<b>AMENDMENT OF SOLICITATION/MODIFICATION OF CONTRACT</b>			1. CONTRACT ID CODE J	PAGE OF PAGES 1   2
2. AMENDMENT/MODIFICATION NO. 0001	3. EFFECTIVE DATE 14-Jul-2006	4. REQUISITION/PURCHASE REQ. NO.		5. PROJECT NO.(If applicable) ED-06-115

14. DESCRIPTION OF AMENDMENT/MODIFICATION (Organized by UCF section headings, including solicitation/contract subject matter where feasible.)  The above-numbered contract for Mississippi River Gulf Outlet, 2006 Foreshore Protection Repairs, Mile 60 to Mile 47, South Bank, St. Bernard Parish, LA, is hereby amended as shown on the following pages.  There are no other changes as a result of this amendment.  The bid opening date and time remain unchanged as 24 July 2006, 2:00 p.m. CST.				
Except as provided herein, all terms and conditions of the document referenced in Item 9A or 10A, as heretofore changed, remains unchanged and in full force and effect.				
15A. NAME AND TITLE OF SIGNER (Type or print)		16A. NAME AND TITLE OF CONTRACTING OFFICER (Type or print)		
		TEL:	EMAIL:	
15B. CONTRACTOR/OFFEROR	15C. DATE SIGNED	16B. UNITED STATES OF AMERICA		16C. DATE SIGNED
_____ (Signature of person authorized to sign)		BY _____ (Signature of Contracting

**RIPRAP GRADATION CURVES**

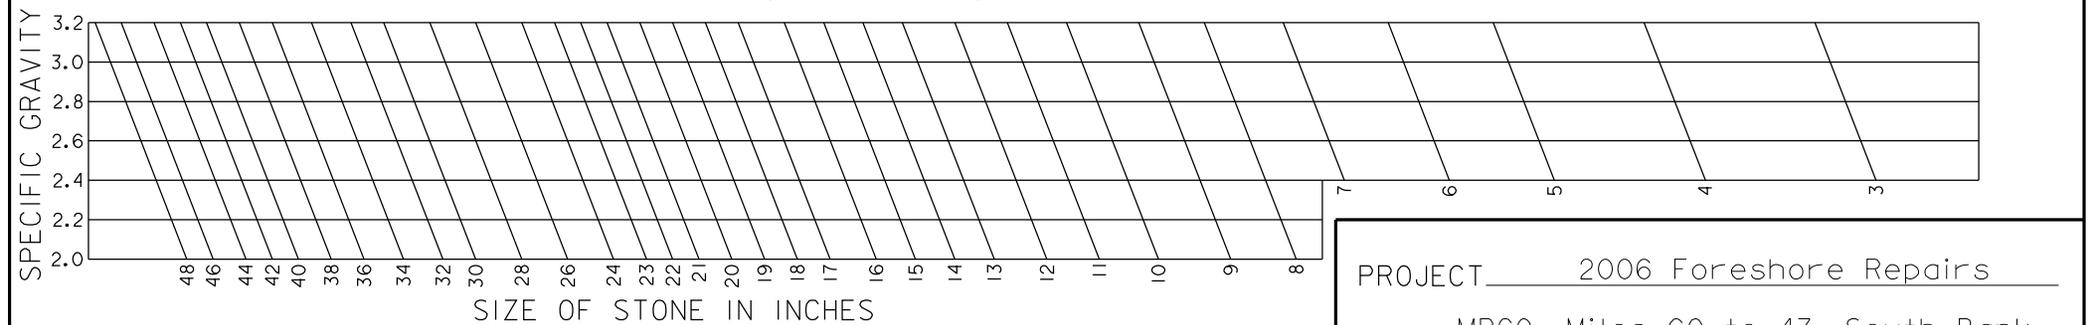
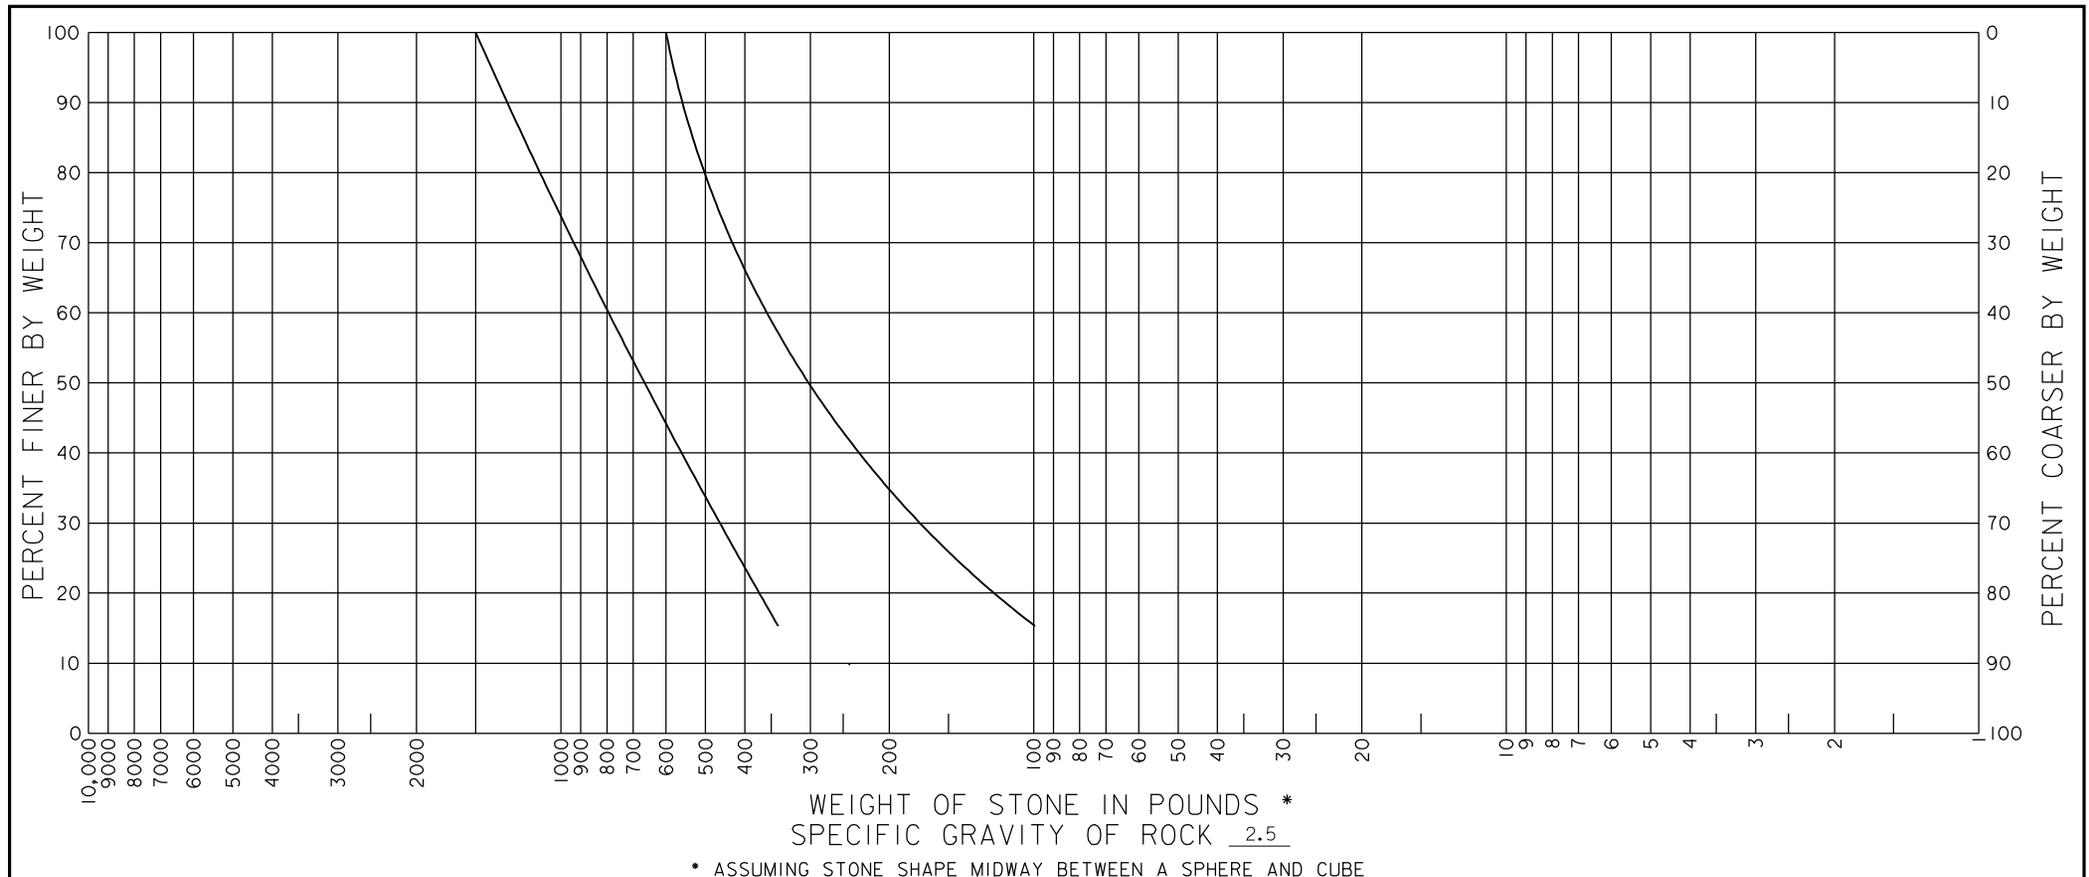
Add the attached Riprap Gradation Curve to the end of this section.

<u>Revetment Stone</u>	<u>Stone Wt. In Lbs.</u>	<u>Percent Finer By Wt.</u>
	1500-600	100
	650-300	50
	330-100	15
